# IEEE 802.1Qcp Update

## Bridges and Bridged Networks Amendment: YANG Data Model

Marc Holness  
Version 0.1  
18 May 2016

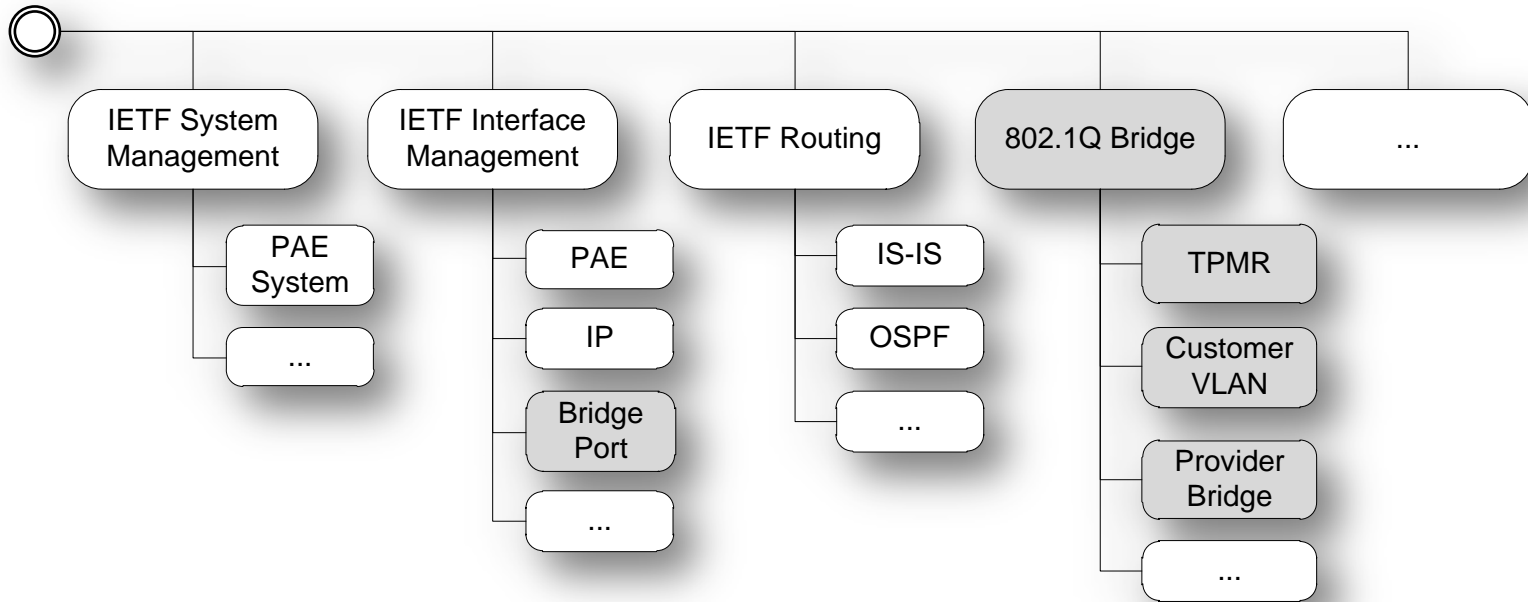
*RFC 6020 which is YANG 1.0 is referred. The IETF is close to approve YANG 1.1 (rfc6020bis) and announced that further YANG modules in the IETF will use 1.1. Taking into account the timeline of this project and the fact that this is the first YANG project in IEEE 802.1, I suggest that development of the YANG modules starting with this project is done in YANG 1.1*

- How will introducing this dependency affect the schedule and progression of 802.1Qcp (and 802.1Xck)?
- I'm hesitant to introduce this dependency at this time.
- Can we not stick with YANG 1.0, and when YANG 1.1 (i.e., draft-ietf-netmod-rfc6020bis-12) becomes an RFC, we can revisit?
